**Subject:** Data Gaps Work Plan

**Subject:** Conditional Approval of Surface Geophysical Data Collection portion of Data Gaps Work Plan

Figures to Accompany  
*Conditional Approval of Surface Geophysical  
Data Collection portion of Data Gaps Work Plan*

**To:** EPA  
**Copy To:** File 80021  
**From:** J. Lambert, J. Brunelle  
**Subject:** Olin: Comprehensive Data Gaps Work Plan Review Comments  
**Date:** 8/22/19

EPA REVISED  
SEISMIC LINE  
8

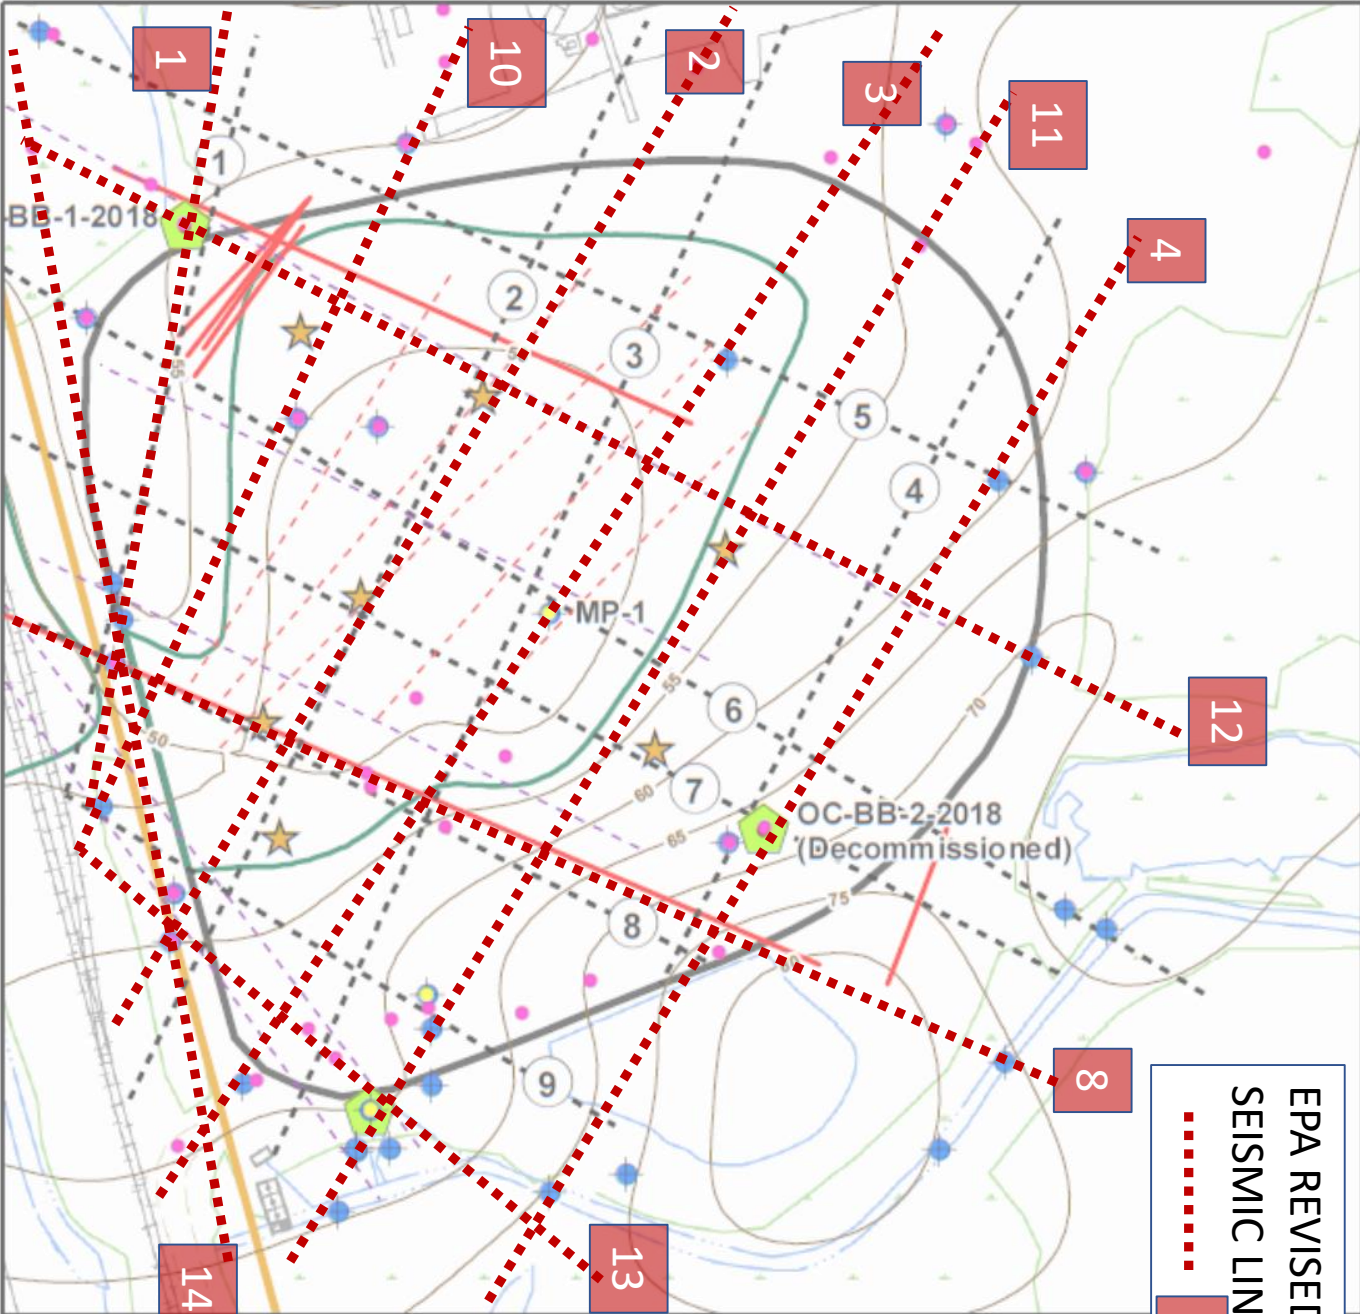
7. **Containment Area Seismic Alignments:** The majority of the geophysical alignments proposed for the Containment area are generally acceptable. However, a closer examination with the recent drilling experience in the CA during November 2019, suggest a few minor modifications should at least be considered, as summarized in the following table and associated figure. EPA is proposing several slight adjustments to the alignments in order to maximize overlap with existing boreholes. This will serve to improve and constrain the seismic data as well as to validate previous estimations of bedrock from other methods such as bedrock "refusal" or other estimations from drilling. Significant discrepancies, if any, will thus be highlighted. In addition to the proposed modification, several new lines are proposed to increase resolution in key areas of the site and to normalize line spacing to create a more regular grid spacing which will contribute to a better result by increasing resolution and decreasing bias.

Geophysical Survey Line	Status	Comment
1	Modify	Rotate slightly <i>counterclockwise</i> to intersect OC-BB-1-2018, GW-CA2, GW-24 (see figure)
2	Modify	Rotate slightly <i>clockwise</i> to intersect GW-408S/D, (see figure)
3	Modify	Center on MP-1 and rotate slightly <i>clockwise</i> to intersect GW-38D
4	Modify	Center on OC-BB-2-2018 and rotate slightly <i>clockwise</i> as shown on attached figure to maximize control point intersections
5	Concur	
6	Concur	
7	Concur	
8	Modify	Extend 200 feet to southeast to intersect control point shown on attached figure
9	Concur	
10	New	New line to increase/normalize resolution in northwest quadrant of CA; line extends from railroad track on SW end to GW-24, to GW-22D, to GW-34SR, and approximately 50 feet further to the northeast on the same alignment
11	New	New line to increase/normalize resolution in CA, particularly in northeast quadrant where recent drilling detected anomalous deep areas on TOR surface ; line extends from south ditch on SW end to GW-202BRS/D, to PZ-24, through control points near GW-6S/D shown on attached figure and approximately 50 feet further to the northeast on the same alignment

12	New	New line to increase/normalize NW-SE resolution in northwest quadrant of CA; alignment connects OC-BB-1-2018 with GW-412 to the SE, extending approximately 100 feet southeast of the slurry wall and ~ 100 feet northwest of OC-BB-1-2018 on the same NW-SE alignment, intersecting the unlabeled control points shown on the attached figure.
13	New	New line to address critical region in southwest corner of slurry wall; alignment connects GW-408D with GW-202BRS/D to the SE, extending approximately 100 feet southeast of the slurry wall and ~ 50 feet northwest of GW-408D on the same NW-SE alignment
14	New	New Line to assess conditions at critical western margin of CA to better constrain possible geologic controls and connections with Jewel Drive DAPL pool. Alignment begins near the weir structure and South Ditch and extends (from S to N) through GW-38D, GW-408D, GW-37D, GW-CA1 and beyond to the northeast as shown on the attached figure

Figure 3

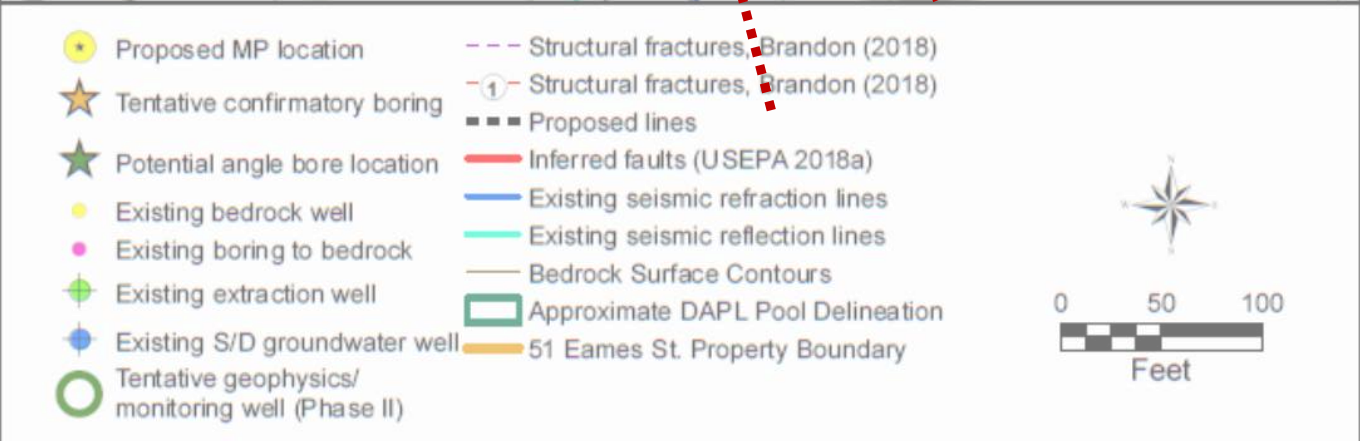
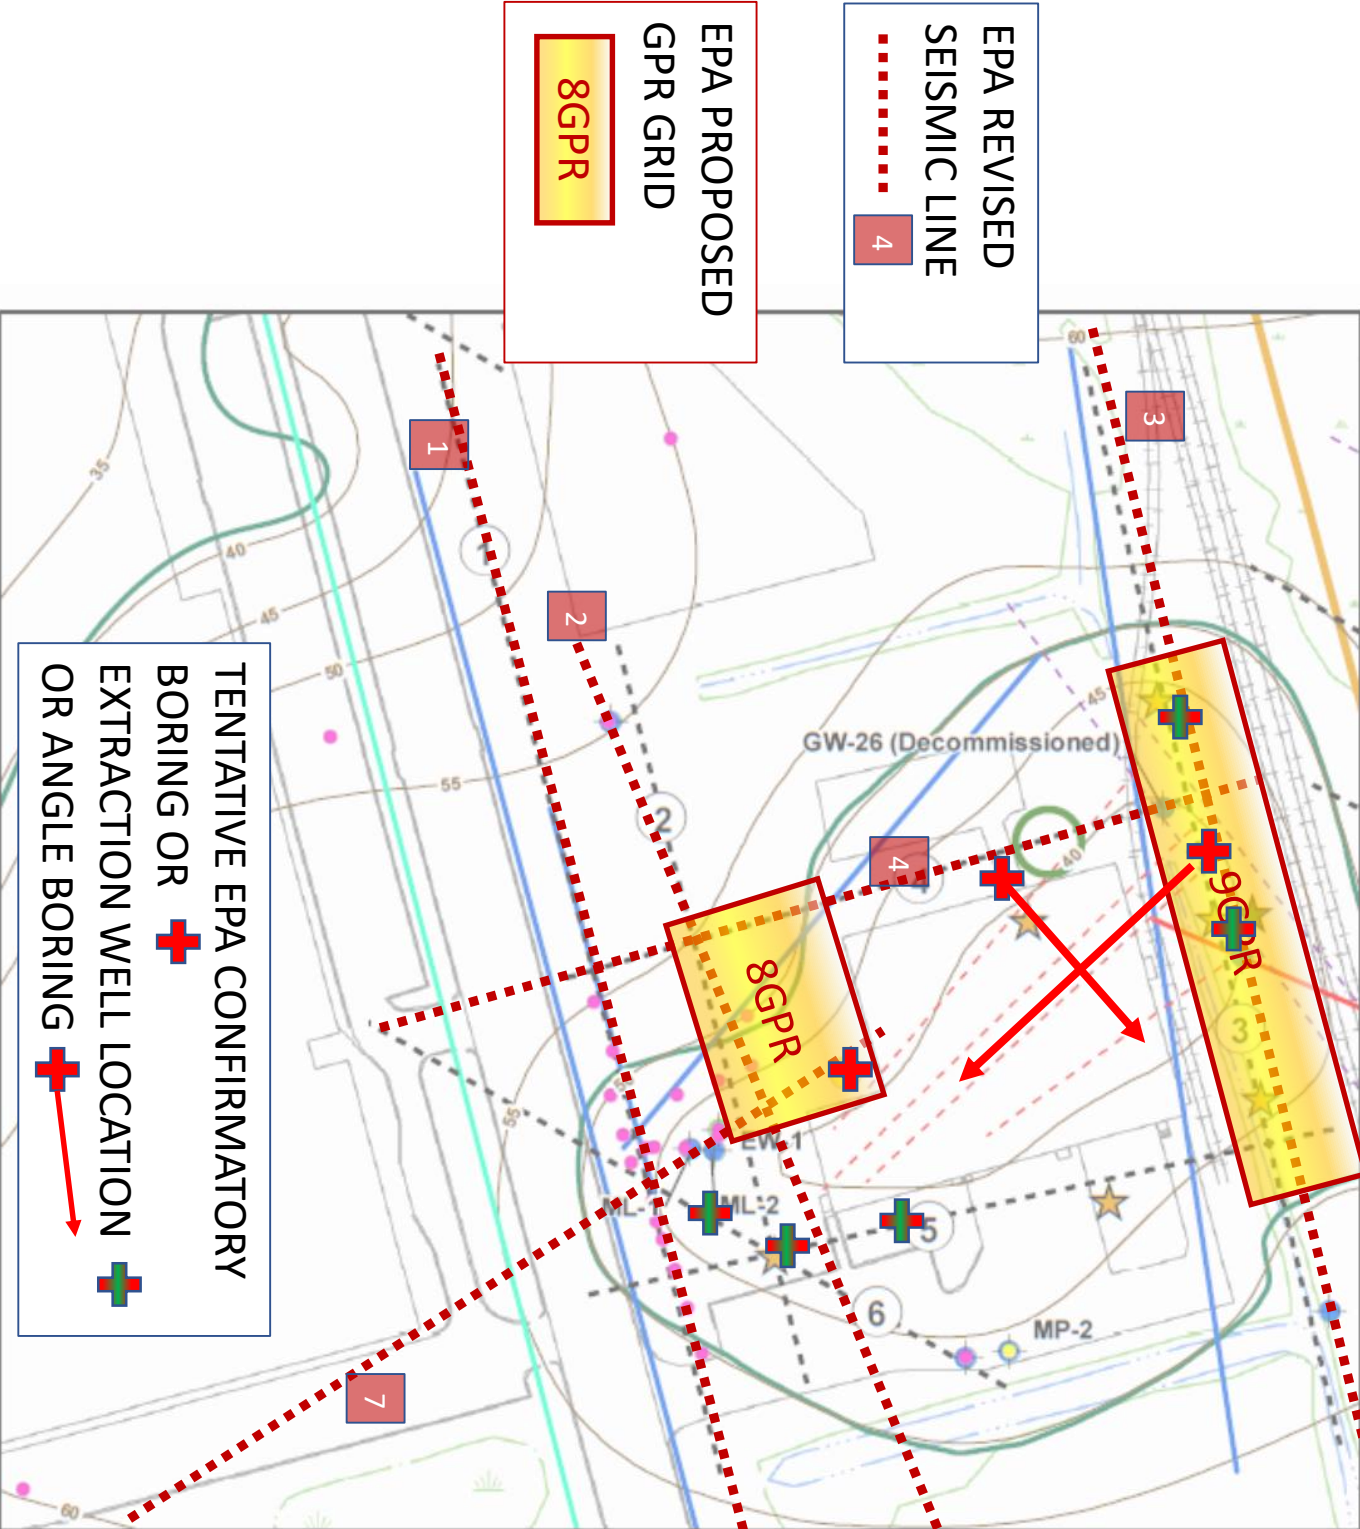
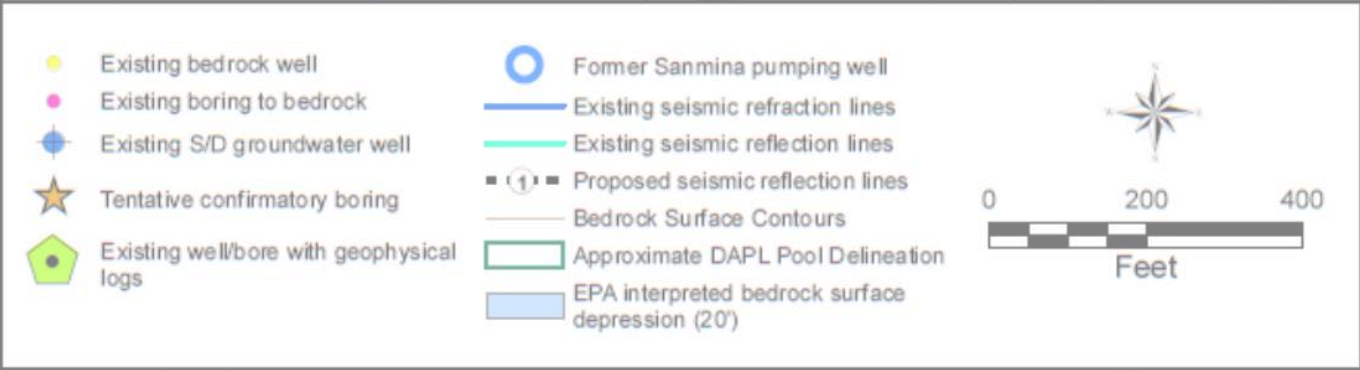
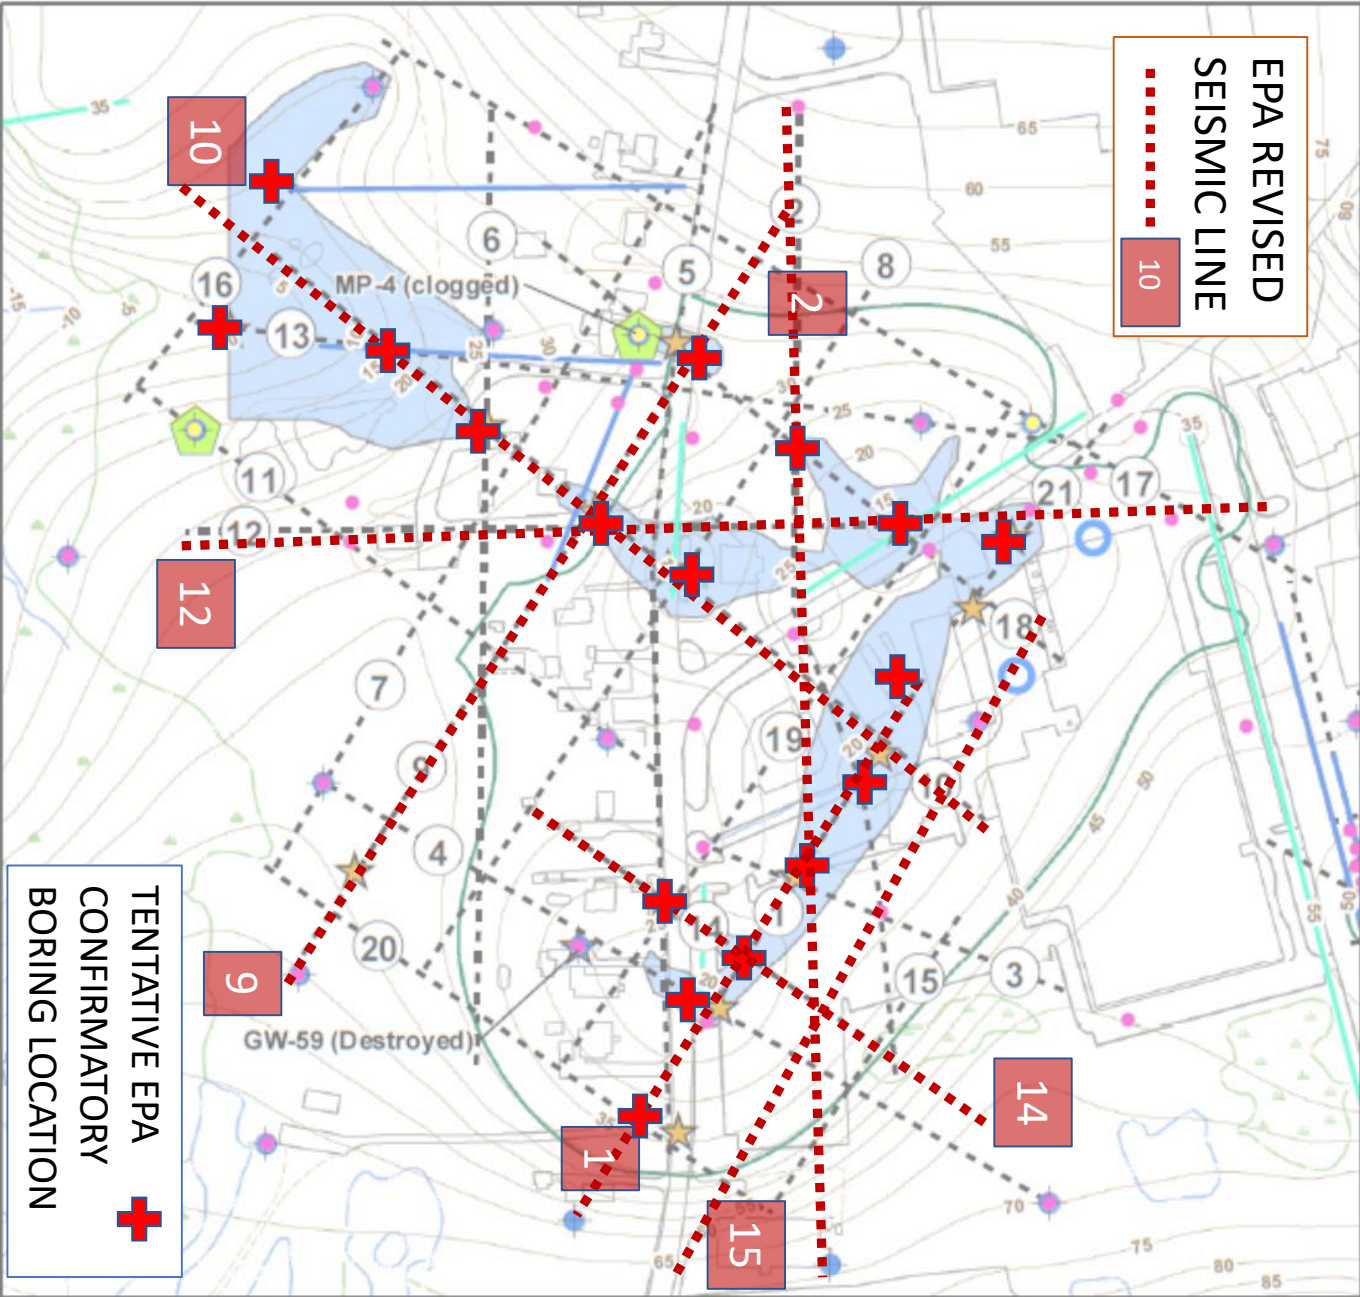
The following table contains limited suggestions for modifications or additions to proposed seismic reflection survey alignments in the Main Street DAPL pool area. It must be acknowledged that the scale of MSDP area is much larger than the CA and Jewel drive areas previously discussed. The proposed seismic surveys will therefore result in a coarser “grid” and hence a lower level of resolution than that which will be obtained for the CA and Jewel drive areas. It may be necessary to collect additional seismic data at a tighter line spacing in selected areas of the MSDP area as a follow-up. We propose deferring decisions in this regard until the currently proposed data is collected, evaluated, and transmitted for discussion.

Geophysical Survey Line	Status	Comment
1	Concur/Extend	Consider extending ~ 300 ft to SW to intersect control point and to evaluate potential continuity of NE-SW oriented bedrock low across Main Street
2	Modify	Rotate slightly to NW to maximize intersection with control points; Eliminate “dog-leg” portion of the line to the SE and extend northern segment of revised alignment southward to southern end of MSDP area
3	Concur/Extend	Consider extending ~ 100 feet to SE to intersect control point
4	Concur	
5	Concur	
6	Concur	
7	Concur	
8	Concur	
9	Concur/Extend	Extend ~ 200 ft to NE to intersect control point and better define northern edge of smaller depression

10	Concur/Extend	Extend ~ 100+ ft to NW to intersect line 16 and possible NE-SW striking feature near the projected intersection with line 16
11	Concur	
12	Concur/Extend	Extend ~ 300 ft to east to intersect control points and line 17; provide additional data in vicinity of former Stamina pumping well
13	Concur	
14	Concur/Extend	Extend 100-200 ft to SE to interrogate subsurface beneath small wetland feature
15	Replace	Eliminate proposed alignment and replace with new alignment shown on figure to intersect control points and line 18; provide additional data in vicinity of former Stamina pumping well
16	Concur	
17	Concur	
18	Concur	
19	Concur	
20	Concur	
21	Concur

11. Main Street DAPL Pool Area, proposed confirmatory borings/extraction well locations; EPA tentatively has selected the 17 locations shown on the attached figure as tentative locations for TOR confirmation and/or DAPL extraction in view of the current CSM. The number and locations for proposed extraction wells, multi-port monitoring wells, and conventional monitoring wells in key hydrostratigraphic zones will be revisited and revised as necessary based on the new information to be collected.
